PLANNING AND ZONING COMMISSION MEETING
Tuesday, March 26, 2024 • 7:00 p.m.
West Branch City Council Chambers, 110 N. Poplar St.
Council Quorum May Be Present

SITE PLAN REVIEW CHECKLIST

Project Name Newport Fab and Machine

DRAWINGS FOR PROPOSED IMPROVEMENTS NEWPORT FAB AND MACHINE SITE PLAN

SITE & UTILITY PLAN

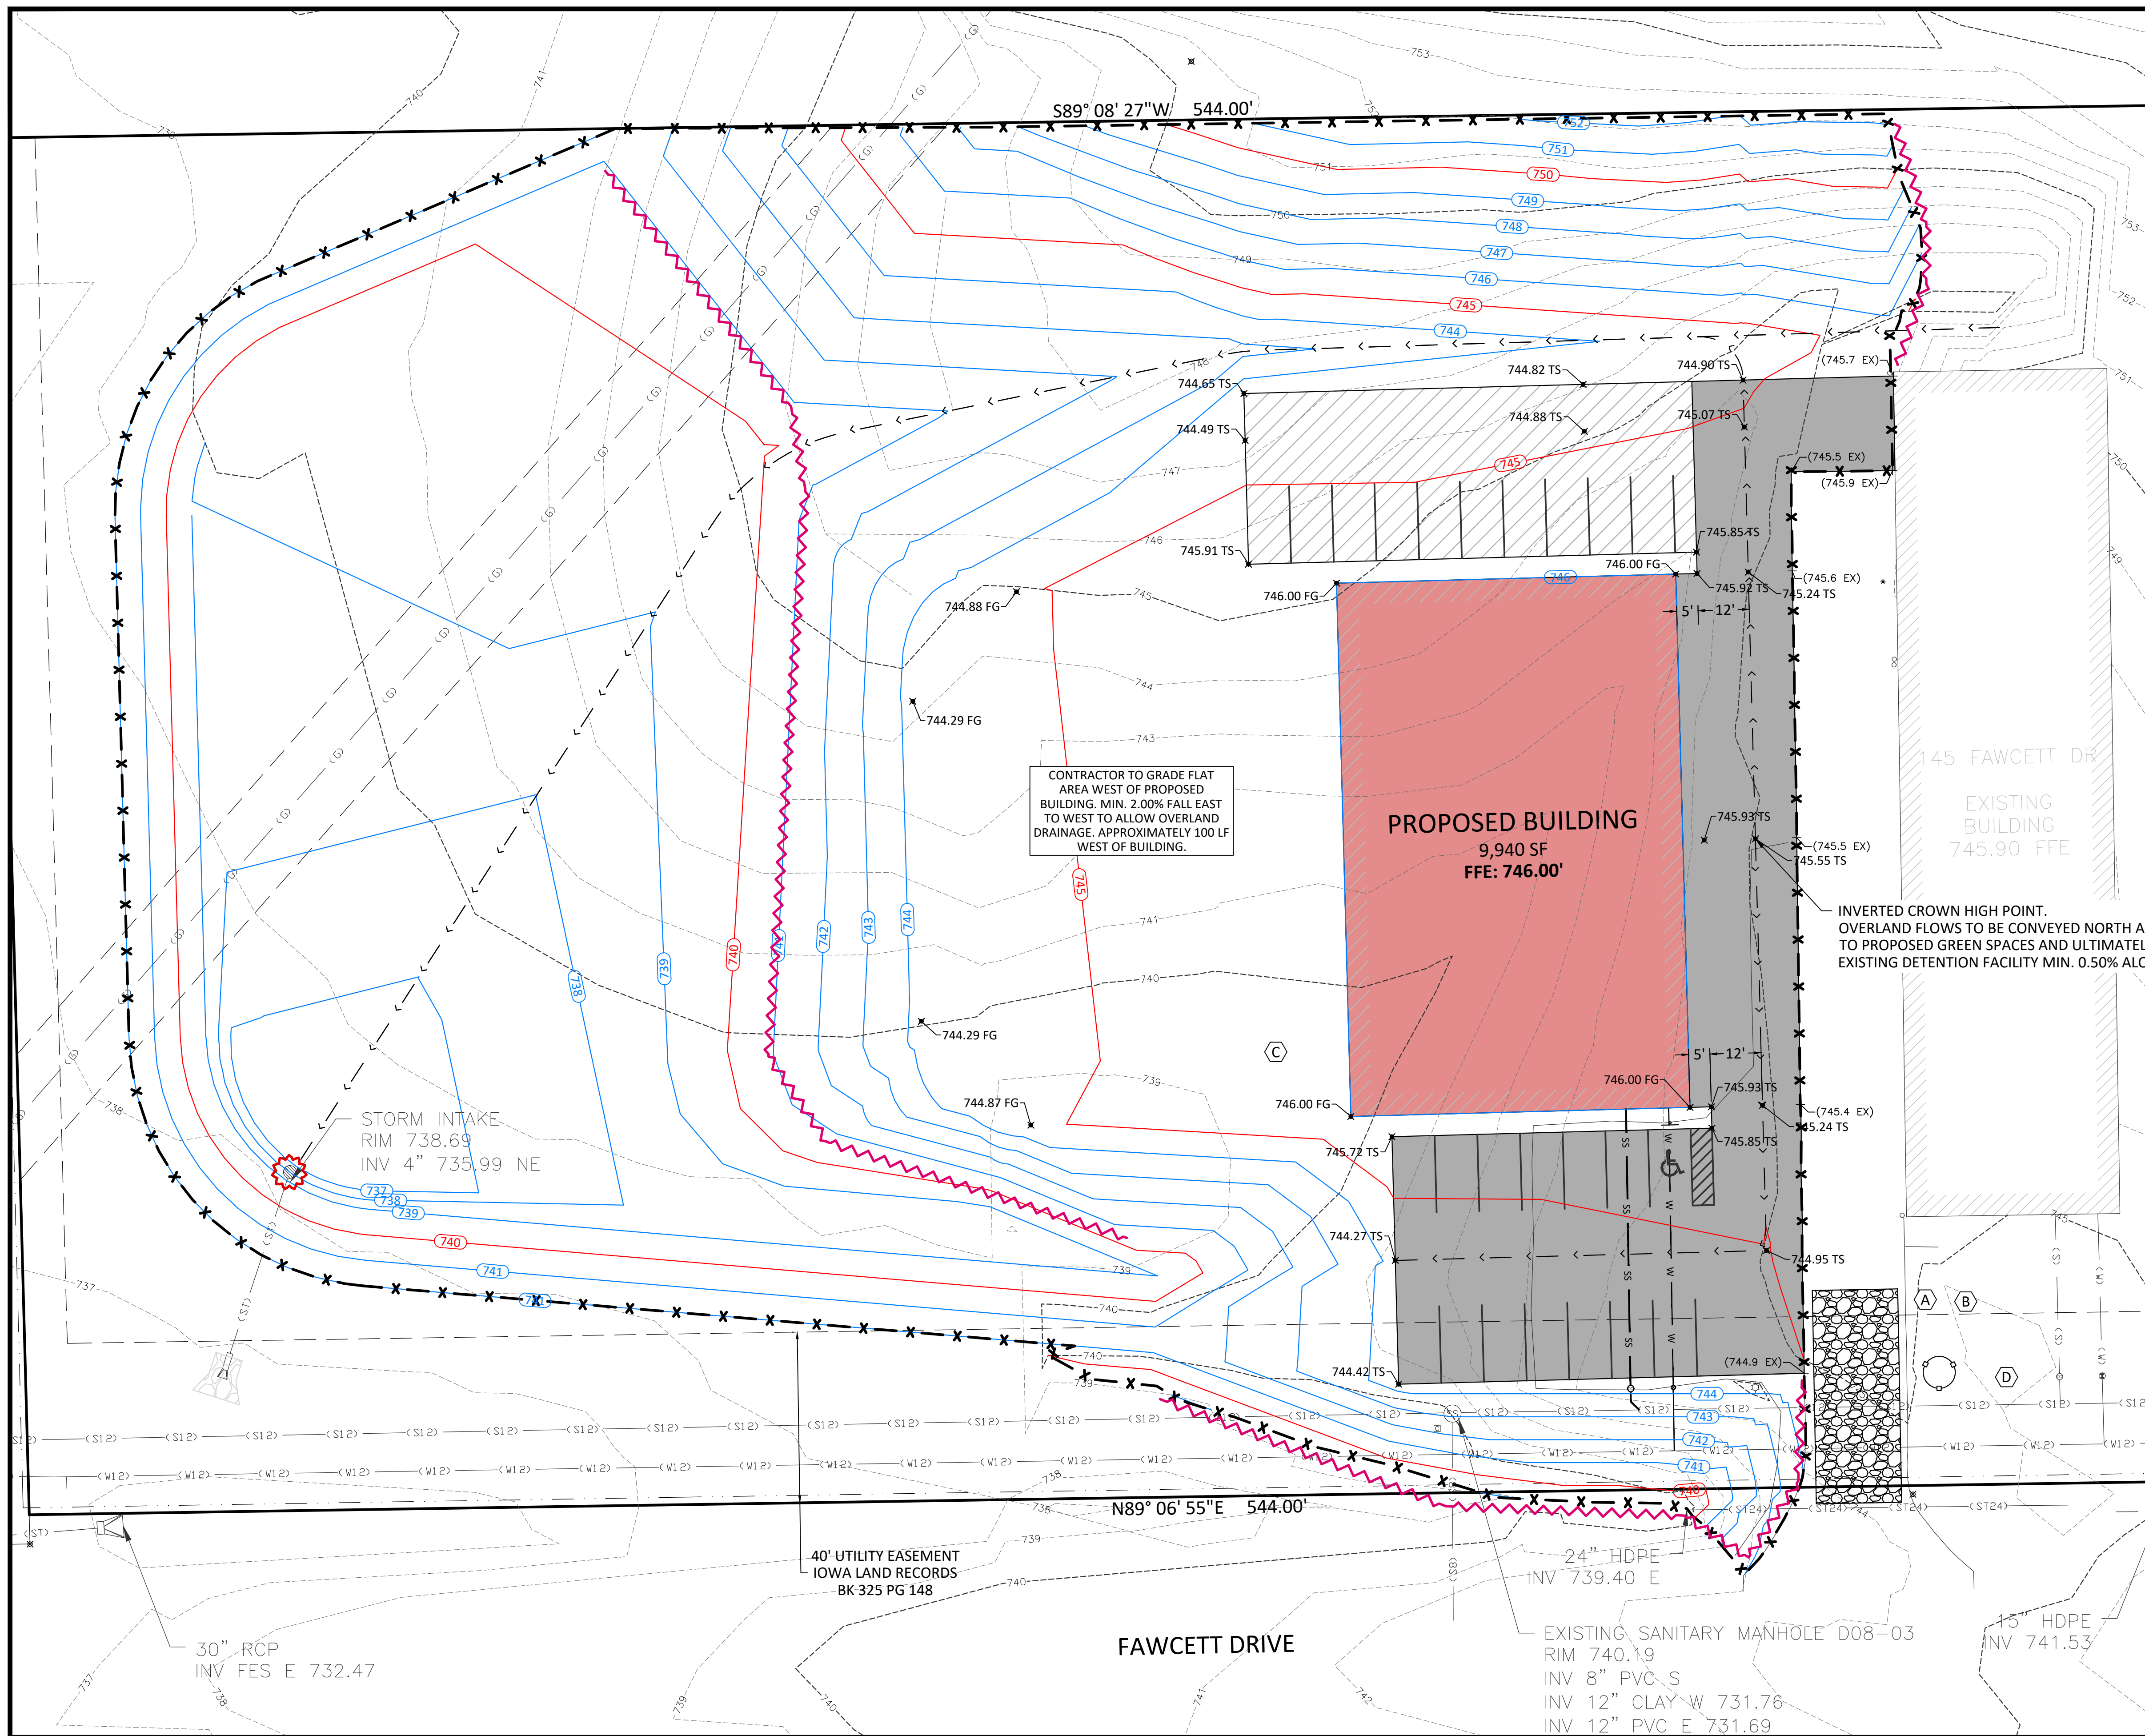
- a. Any other zoning district, other than an Agricultural A-1 District, that abuts any residential district shall require a buffer as described in this section. The buffer shall be provided by the non-residential use when adjoining a residential district. YES NO **N/A**
- b. All Industrial Districts that abut any other district shall provide a buffer as required by this section. YES NO **N/A**
- c. Any storage area, garbage storage, junk storage or loading docks, and loading areas, in any District shall be screened from public street view by a buffer YES NO
Note garbage storage area and provide screening.

- a. All parking areas be aesthetically improved to reduce obtrusive characteristics that are inherent to their use. *Provide hard surface parking* YES NO
- b. Parking areas shall be effectively screened from general public view and contain shade trees within parking islands where multiple aisles of parking exist. Not less than five (5) percent of the interior parking area shall be landscaped within parking islands. YES NO **N/A**

- a. forward movement of the vehicle. YES NO
- b. Driveway approach returns shall not extend beyond the side lot line as extended. *provide 2' wide flare minimum offset from edge of pavement.* YES NO
- c. The number of ingress/egress access points to public streets from offstreet parking areas located to limit vehicular conflicts, preserve proper traffic safety. YES NO

GRADING & EROSION CONTROL PLAN

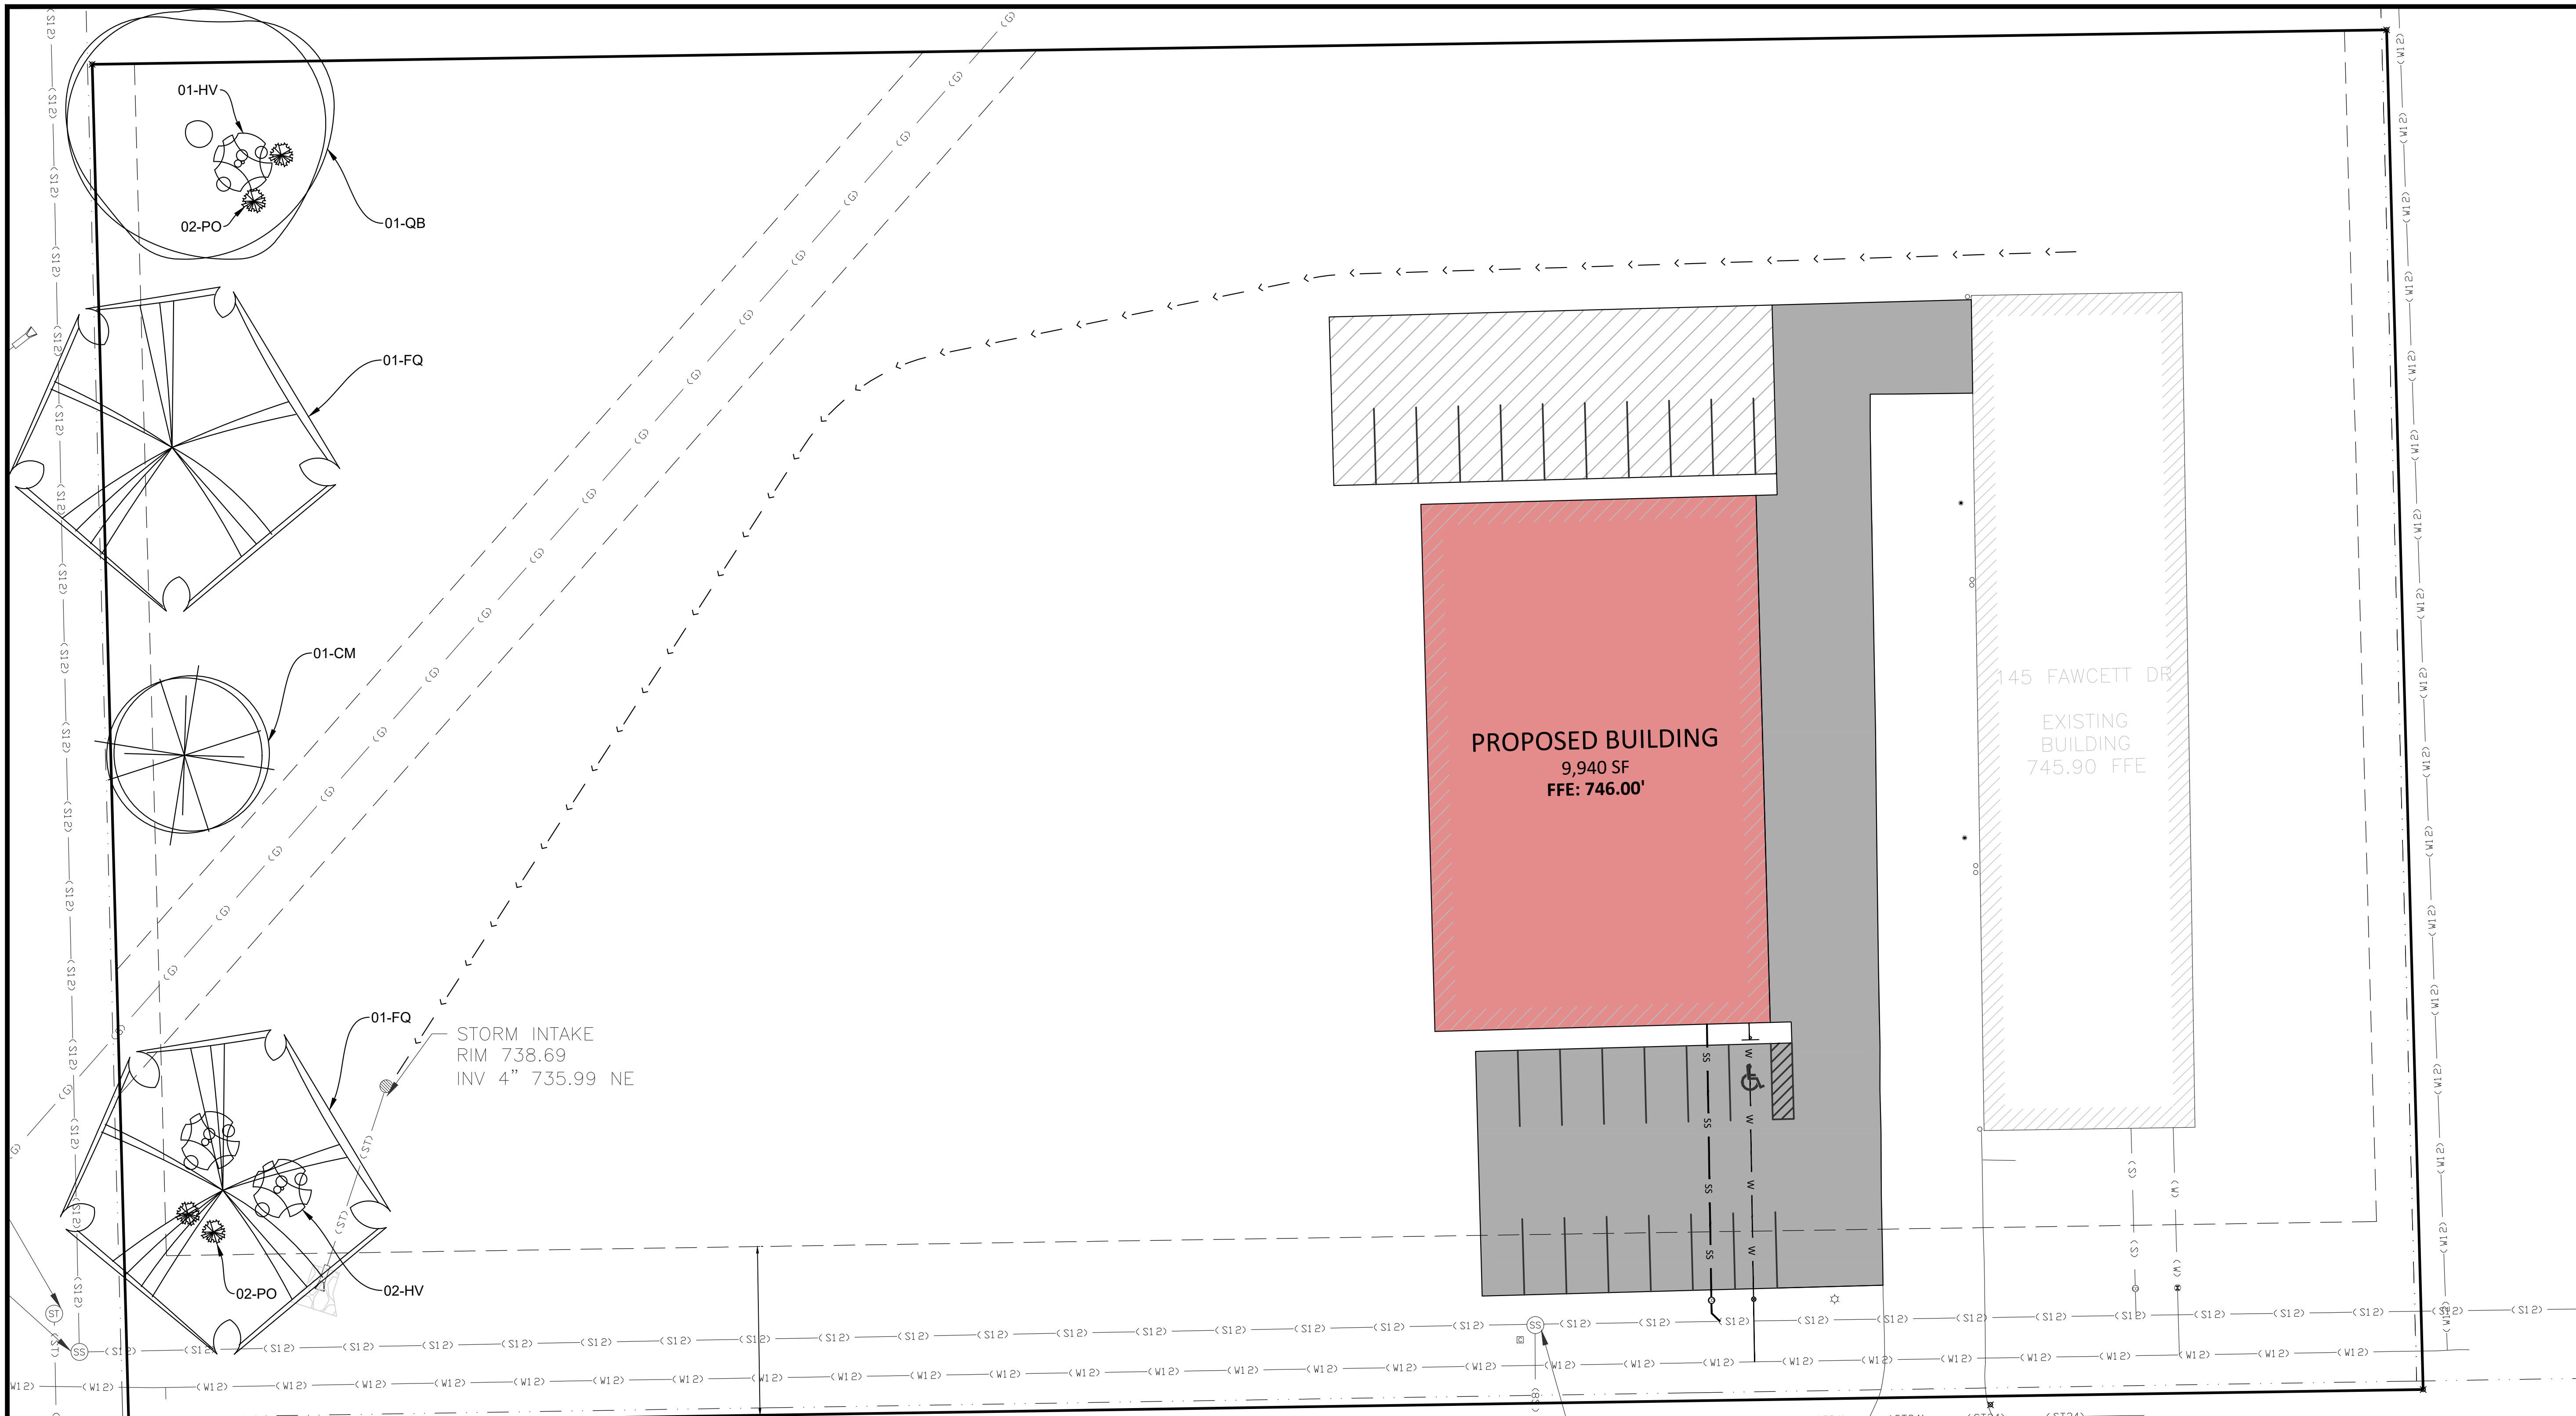
17. Where possible ownership or boundary problems exist... [] YES [] NO N/A
18. Stormwater Pollution Prevention Plan. [X] YES [] NO
19. Stormwater Management Plan. [] YES [X] NO
